FINAL INITIAL STUDY/MITIGATED
NEGATIVE DECLARATION
FOR THE
HARDT AND BRIER BUSINESS PARK
PROJECT

April 2024

CHAPTER 2: RESPONSE TO COMMENTS

Figure 1. Actual and predicted relationships between the number of vertebrate wildlife species detected and the elapsed survey time based on Noriko’s visual-scan survey on 23 November 2023. Note that the relationship would differ if the survey was based on another method or during another season.

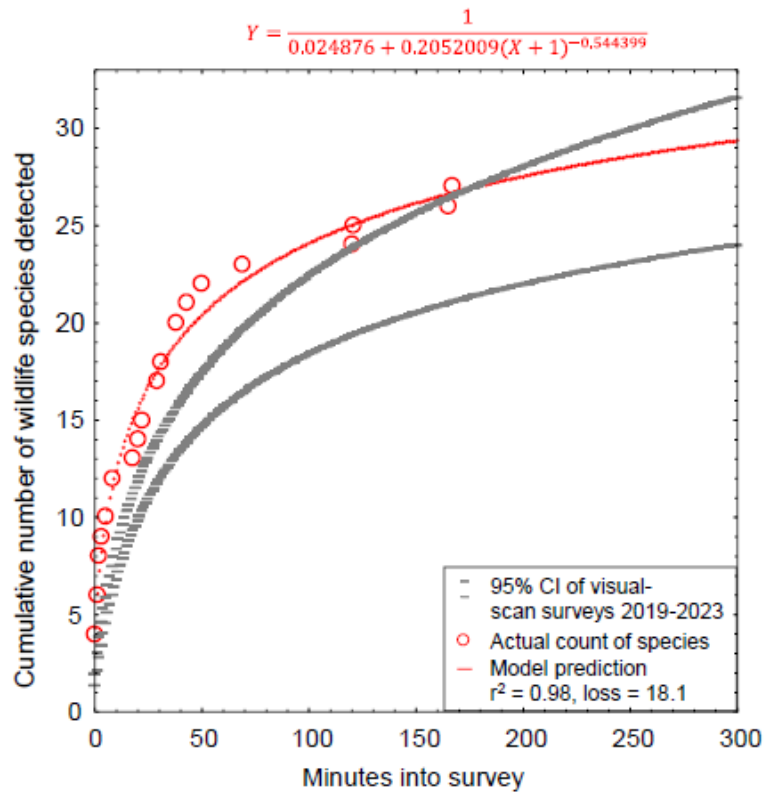
I fit a nonlinear regression model to Noriko’s cumulative number of vertebrate species detected with time into her survey to predict the number of species that she would have detected with a longer survey or perhaps with additional biologists available to assist her. The model is a logistic growth model which reaches an asymptote that corresponds with the maximum number of vertebrate wildlife species that could have been detected during the survey. In this case, the model predicts 40 species of vertebrate wildlife were available to be detected on the morning of the 23rd, which left 13 species undetected during her survey (Figure 1). Unfortunately, I do not know the identities of those 13 species Noriko missed, but the pattern in her data indicates relatively high use of the project site compared to 53 surveys at other sites she and I have completed in the region. Compared to models fit to data I collected from 53 other sites in the region between 2019 and 2023, the data from the New Hardt project site mostly exceeded the upper bound of the 95% confidence interval of the rate of accumulated species detections with time into the survey (Figure 1). Importantly, however, the species Noriko did and did not detect on November 23 composed only a fraction of the species that would occur at the project site over the period of a year or longer. This is because many species are seasonal in their occurrence.

2b.3

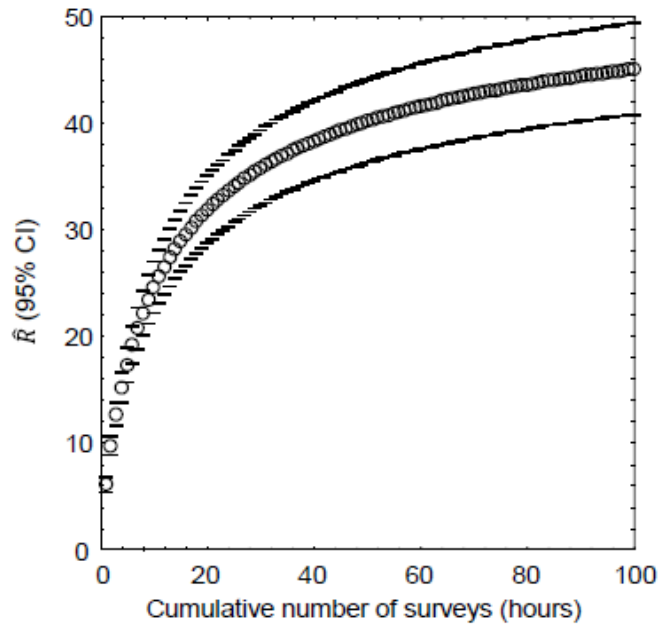
I projected the predictions of each model to thousands of hours to find predicted asymptotes of wildlife species richness. The mean model-predicted asymptote of species richness was 57 after 11,857 hours of visual-scan surveys among the 46 stations of my research site. I also averaged model predictions of species richness at each incremental increase of number of surveys, i.e., number of hours (Figure 2). On average I would have detected 13.2 species over my first 3.18 hours of surveys at my research site in the Altamont Pass (3.18 hours to match the 3.18 hours Noriko surveyed at the project site), which composed 23.15% of the predicted total number of species I would detect with a much larger survey effort at the research site. Given the example illustrated in Figure 2, the 27 species Noriko detected after her 3.18 hours of survey at the project site likely represented 23.15% of the species to be detected after many more visual-scan surveys over another year or longer. With many more repeat surveys through the year, Noriko would likely detect $27 / 0.2315 = 117$ species of vertebrate wildlife at the site. Assuming Noriko's ratio of special-status to non-special-status species was to hold through the detections of all 117 predicted species, then continued surveys would eventually detect 22 special-status species of vertebrate wildlife.

Because my prediction of 117 species of vertebrate wildlife, including 22 special-status species of vertebrate wildlife, is derived from daytime visual-scan surveys, and would detect few nocturnal mammals such as bats, the true number of species composing the wildlife community of the site must be larger. Noriko's reconnaissance survey should serve only as a starting point toward characterization of the site's wildlife community, but it certainly cannot alone inform of the inventory of species that use the site. More surveys are needed than her one survey to inventory use of the project site by wildlife.

Nevertheless, the large number of species I predict at the project site is indicative of a relatively species-rich wildlife community that warrants a serious survey effort.

2b.4
Cont.
